Access Compliance Report

Public Rights-of-Way

Intersection ID: 10036601	Main Street: RUSHMORE_DR	Cross Street: N/A	Location: S
ADA ID: 76DD4CA291BE	Ramp Type: PerpDiag	Initial Pass/Fail: Fail	Overall Compliance: No
		Severity Score: 37.5

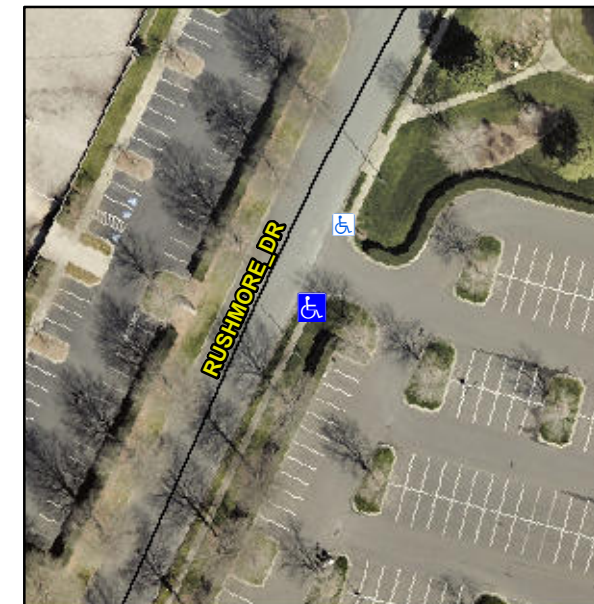
R304.2.2, R304.5.3

Compliance	Description	Data	Compliance	Description	Data
N/A	Ramp Length (in)	45.0	No	Ramp Slope (%)	11.6
Yes	Ramp Width (in)	60.0	No	Ramp XSlope (%)	8.1
N/A	Flare Type LT	N/A	N/A	Flare Type RT	N/A
N/A	Flare Slope LT (%)	N/A	N/A	Flare Slope RT (%)	N/A
N/A	Flare Traversable LT?	N/A	N/A	Flare Traversable RT?	N/A
N/A	Landing Length (in)	N/A	N/A	DWS Provided?	N/A
N/A	Landing Width (in)	N/A	N/A	DWS Contrast?	N/A
N/A	Landing Slope (%)	N/A	N/A	DWS Length (in)	N/A
N/A	Landing X Slope (%)	N/A	N/A	DWS Full Width?	N/A
N/A	Landing Curb? (Y/N)	N/A	N/A	DWS Offset (in)	N/A
N/A	Shared Landing?	N/A			
N/A	Gutter Ponding?	N/A	N/A	Gutter Slope (%)	N/A
N/A	Gutter Lip Ht (in)	N/A	N/A	Gutter X Slope (%)	N/A
N/A	Painted X Walk1?	No	N/A	Painted X Walk2?	No
	X Walk 1 Direction	To NE		X Walk 2 Direction	To NW
N/A	X Walk 1 Width (in)	N/A	N/A	X Walk 2 Width (in)	N/A
	X Walk 1 Slope (%)	0.8		X Walk 2 Slope (%)	7.1
	X Walk 1 X Slope (%)	5.5		X Walk 2 X Slope (%)	0.6

Remove & Replace Curb Ramp With Two New Directional Ramps or Equivalent.
